INFORMATION BULLETIN

NEW SIGNATURE SEAT PAN

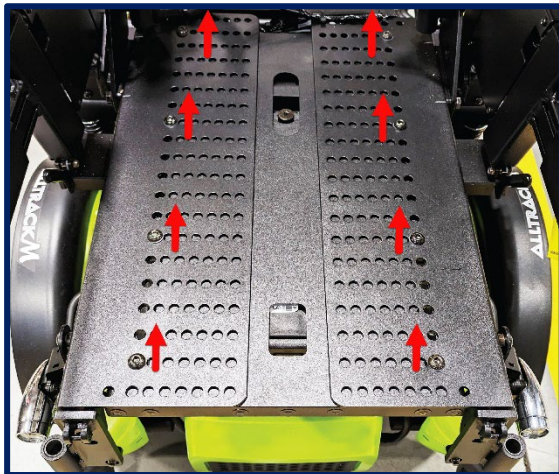
Introduced as a running change, we are happy to announce the release of the next components of our newly re-designed Amyseat Signature Series power seating system. The NEW Signature seat pan provides easier slotted adjustment of width and depth while retaining our well-known structural integrity and durability.

The new design reduces the number of adjustment bolts that must be fully removed while also providing an etched guide to show settings for current and adjusted width settings.

SIDE BY SIDE

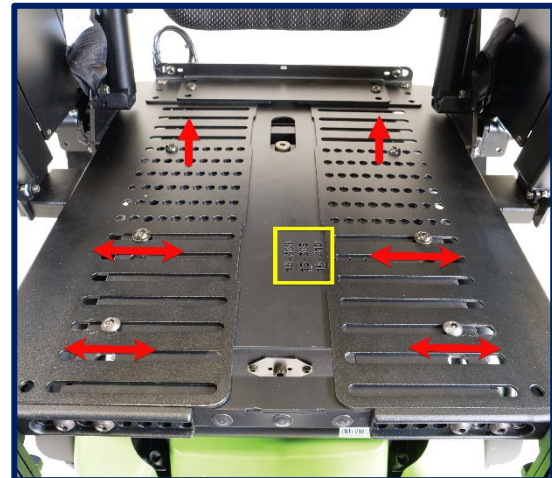
- Adjustment is done by removing all bolts from each of the 2 plates (*suggested to do one side at a time*) and while holding them, move them horizontally to desired width.
- Adjustment can be more time consuming.

- Adjustment is done by loosening all bolts in the slots without removing them, then unscrewing and completely removing the ones in the holes.
- This method keeps both plates in position during adjustment.
- A measurement guide in inches and millimeters is engraved on the base of the pan.
